MDL-MGR-GS-000006 REV 00

Redistribution of Tephra and Waste by Geomorphic Processes Following a Potential Volcanic Eruption at Yucca Mountain, Nevada

Prepared by:
Sandia National Laboratories
OCRWM Lead Laboratory for Repository Systems
1180 Town Center Drive
Las Vegas, Nevada 89144

Figure 1: DEM slope compared to real world slope. The actual topographic profile may have a very different local slope in comparison to a 30-m DEM calculated slope.

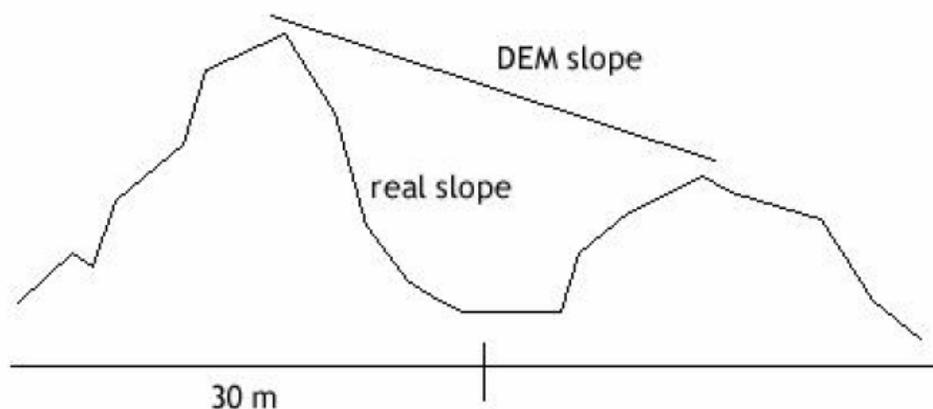
The reviewer does not have a simple method to determine the relation between the DEM slope and the real Fortymile wash drainage basin slopes. Because it is conceivable that the two slope estimates diverge depending on the relief and roughness of the topographic surface (Fig. 1), perhaps the author should provide this comparison.

Originator Response: Such a comparison would require an independent measurement of slope throughout the drainage basin, which is not available. What’s shown in Figure 1 is also unrealistic. On a 30 x 30m grid you will not typically have the type of peaks / valleys that the figure portrays, since such steep slopes would be unstable in this environment, unless composed of solid rock. In addition, DEM errors are considered random in space, and over large areas the general drainage directions therefore will be accurately represented. Errors in slope between the DEM and the reality on the ground may result in mobilized mass being routed to a place in the channel one (or even several) pixel from where it really would go, but on the spatial scale of the upper drainage basin any such errors are insignificant. Plus, because the FAR code uses essentially a “bulk” movement (not a finite difference element), as long as the mobilized

FIGURE 13.—Regional maximum discharge versus drainage area. "Boundary" curve was developed by Crippen and Bue (1977, figure 18) for maximum observed discharges in the flood region that includes the study area.

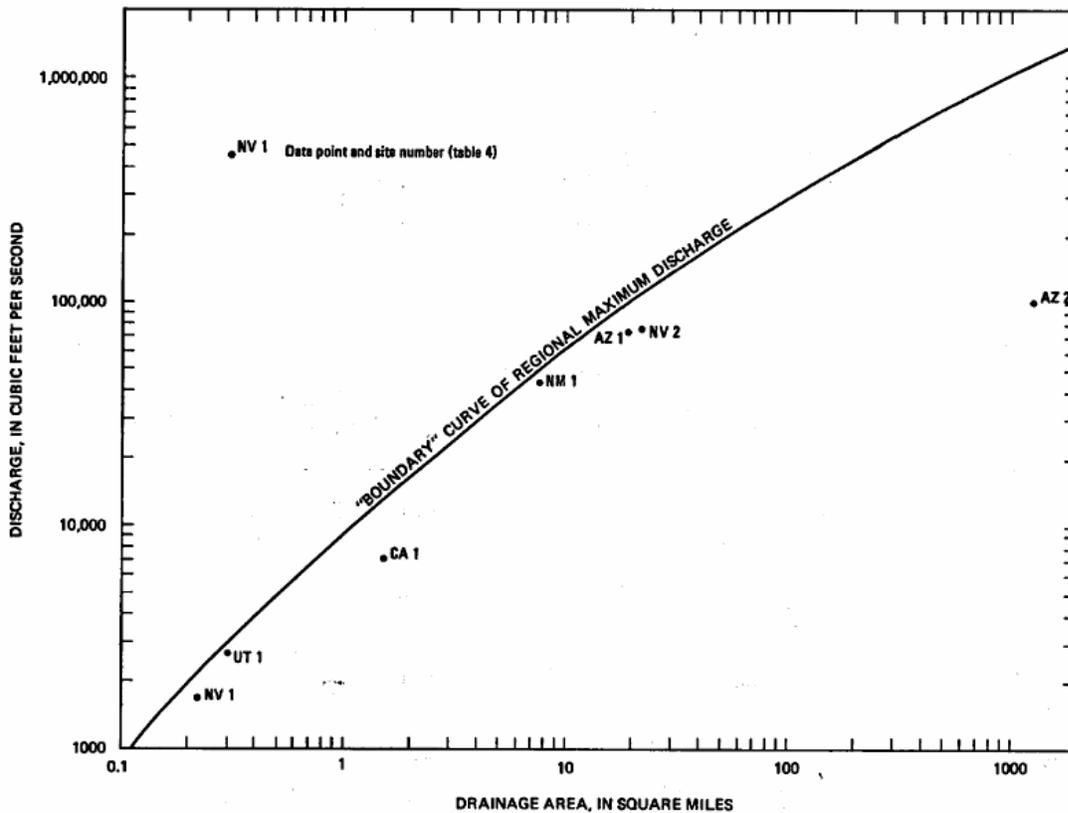
Scour depth, another critical model parameter is calculated on the basis of only two studies. The first study, Squires and Young, 1984, estimated the maximum discharge as a function of contributing area for large floods. They suggest that they are describing floods with a recurrence interval of 100 years and 500 years, although there may be very large uncertainty associated with annual flood probabilities of rare floods. It should be noted that on Figure 13 of the Squire and Young study, there is an outlier.

*Originator Response: **Response to outlier in figure 13:** Figure 13 of Squires and Young (1984 [DIRS 180001], p. 21) is reproduced below. This figure is generated with data from another author (Crippen and Bue 1977 [DIRS 108874], Figure 18), who selected, compiled, and analyzed maximum observed flood peaks nationwide. The figure shown is a "boundary" curve for the five-state region that includes Yucca Mountain, from which the regional maximum flood discharge rates for the site were estimated. These regional discharge rates are significantly*

Figure 8: A) Above, showing contributing area output grid from FAR model. Note that in the inset, once can see that the channels are not always continuous, and appear to form fan shaped features. B) Below, channel definition near fan outlet compared to satellite image.

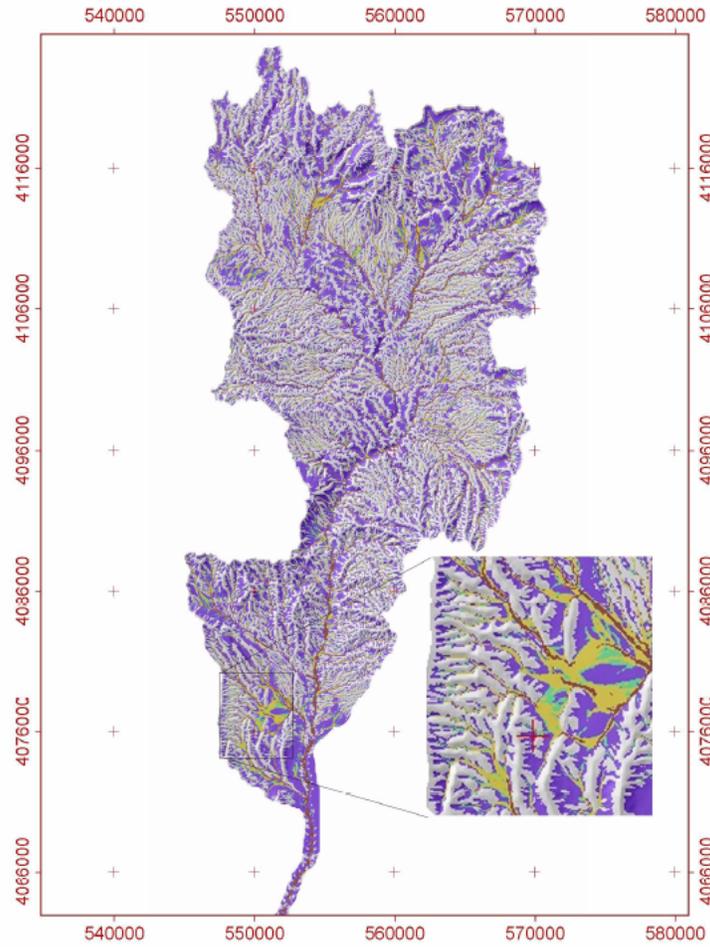
Near the fan outlet, I examined how well the bifurcation method defined the main channel of Fortymile wash (Figure 8B). The resolution of the output I had did not allow precise comparison, however, I suggest a detailed comparison be made.

Figure 9, showing dilution factor output for one set of initial conditions, given in section 6 figure 6.3.3-6. The inset shows the part of the Fortymile wash channel that is used to provide the initial contaminant concentration to the RMEI channels.

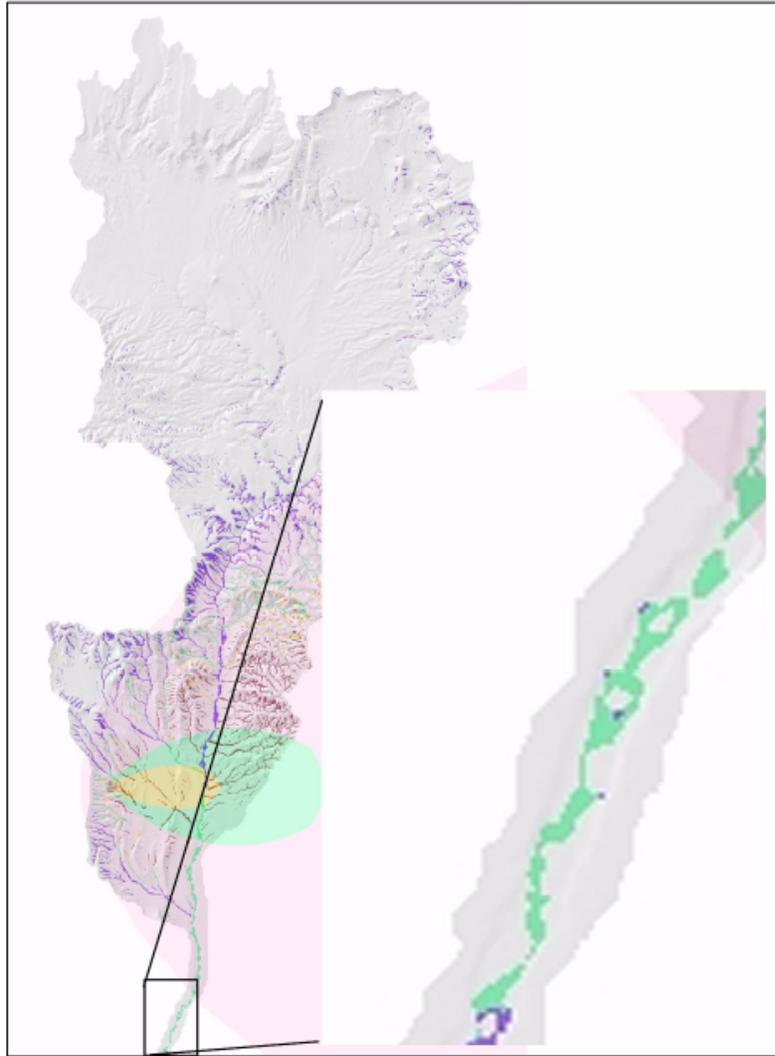
The model output for the dilution factor calculations highlight several relevant concerns regarding the model performance (Fig. 9). I focus on the lower part of the upper drainage basin just before the flow enters the RMEI location. This is the section of Fortymile wash where the dilution factor at the outlet is calculated. It would be useful to identify the single pixel which is actually used for the initial RMEI concentration on that figure.

Note that in the inset (Fig. 9), that the dilution values appear to vary within the channel, in some places appear discontinuous, and for short reaches seems to be concentrated along a channel that is a single pixel wide. The fact that the channel appears to be a single pixel wide in this section of Fortymile wash suggests that the bifurcation method may not be entirely effective in distributing flow correctly for those 500-year floods, or that this figure is not showing the model results correctly.

Also note that although the dilution factor for this model run was in the 0.3 – 0.1 range for most of this section of the wash, at the presumed outlet, the dilution was in the 0.01 - .1 range, or as much as a factor of 10 more dilute. Given the close proximity of these pixels, it would be useful to see what the actual range was, instead of the binned ranges, and to understand fully the impact of picking one particular pixel for the initial RMEI concentration.

Figure 11: showing the Lathrop Wells cone: A) above the tephra sheet, and basalt flows. Note the accumulation of sand blown onto the tephra. B) Below the locations of data used in Lathrop Wells study. Note the area of stream confluence indicated by the white square.

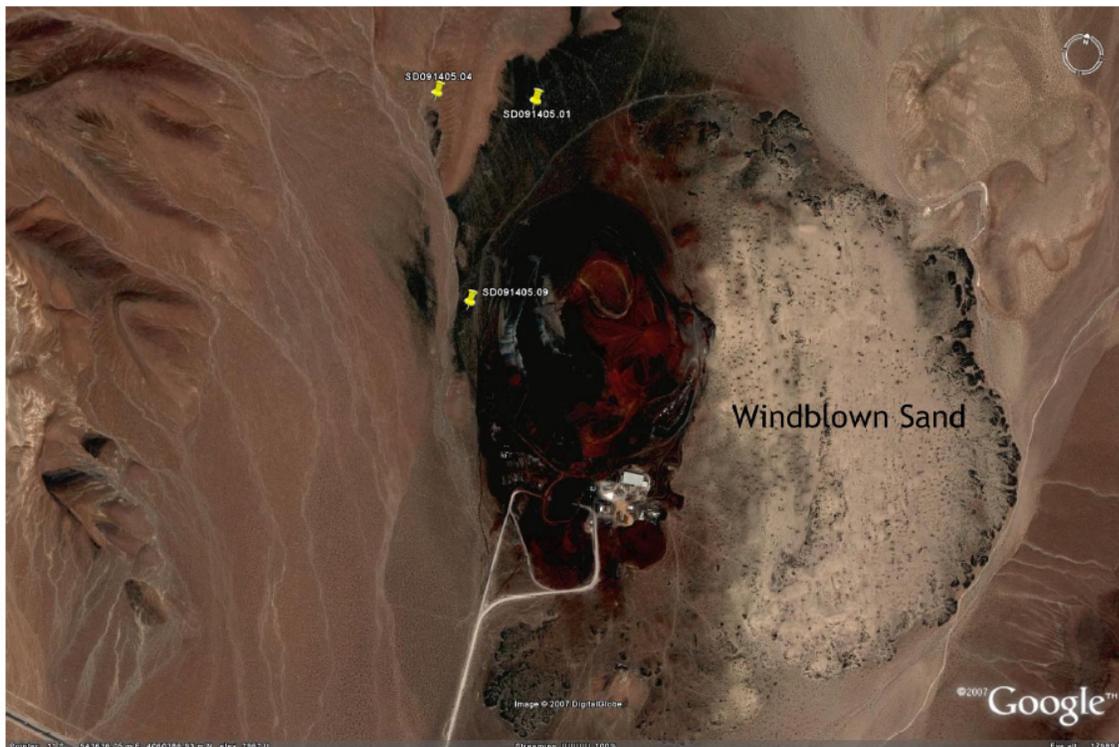
channels probably represent the two classes of concentration. That area is shown in the white rectangle in Figure 11B and plotted in Figure 12 below.
